This page lists the known errors on the gm5x5x5 PCBs. There are no known issues with the bulk order run (white pcbs), the following information is valid **only** for the prototype run (green pcbs).

Prototype Run

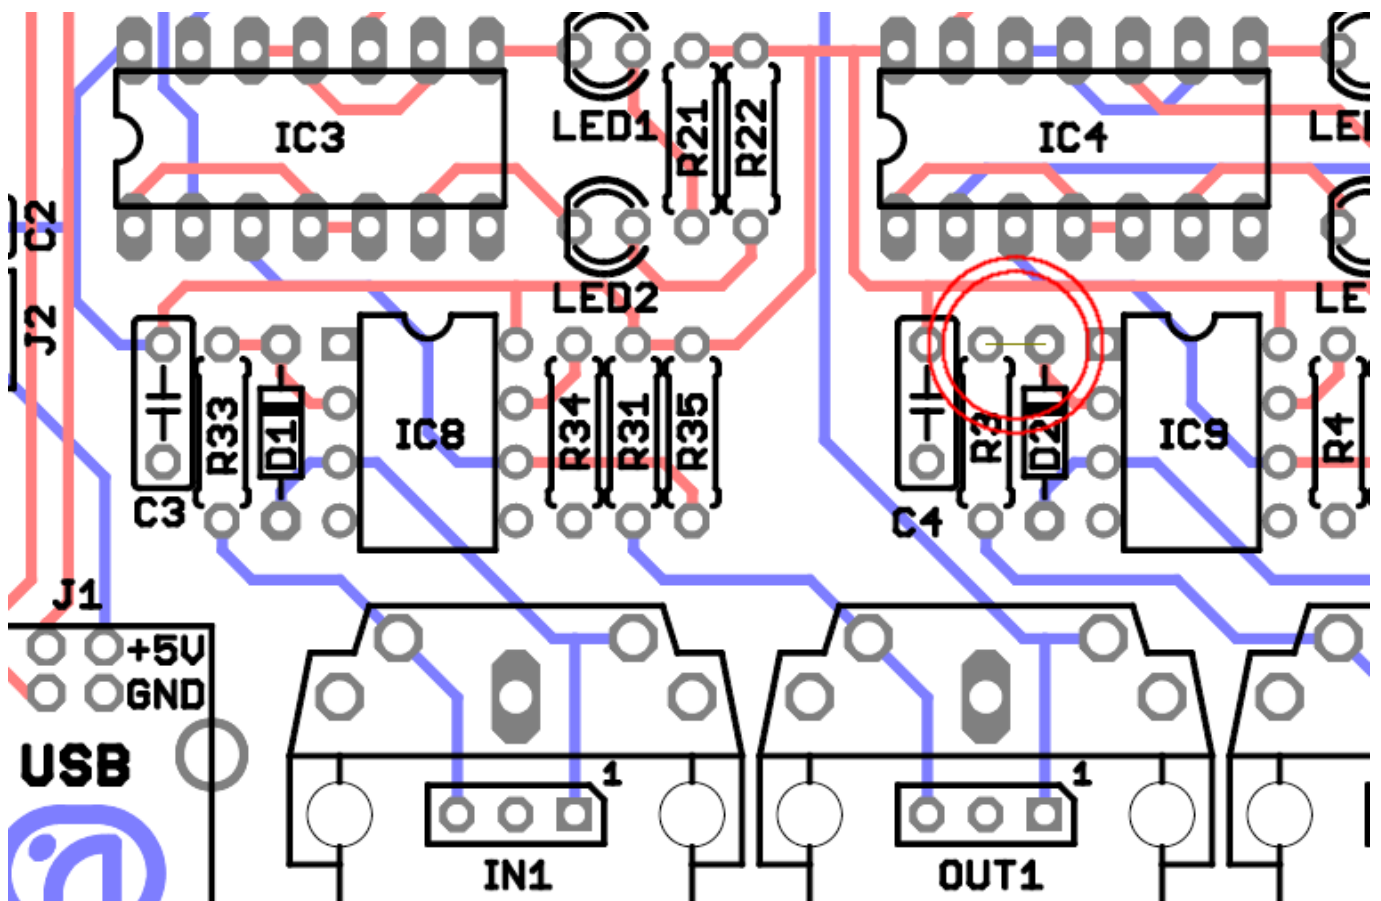
#1 MIDI IO pins

Problem: The MIDI IO pins of the midi sockets (Pin 4 + 5) are switched.

#2 MISSING TRACK

Problem: A track between D2 and R3 is missing.

Solution: Either (1) use the pin-headers if you use sockets that are not mounted on the pcb or (2) break the traces to pins 4 + 5 of the sockets and solder wires to them or (3) solder the midi sockets on the other side of the pcb.

Solution: Bridge the pins.
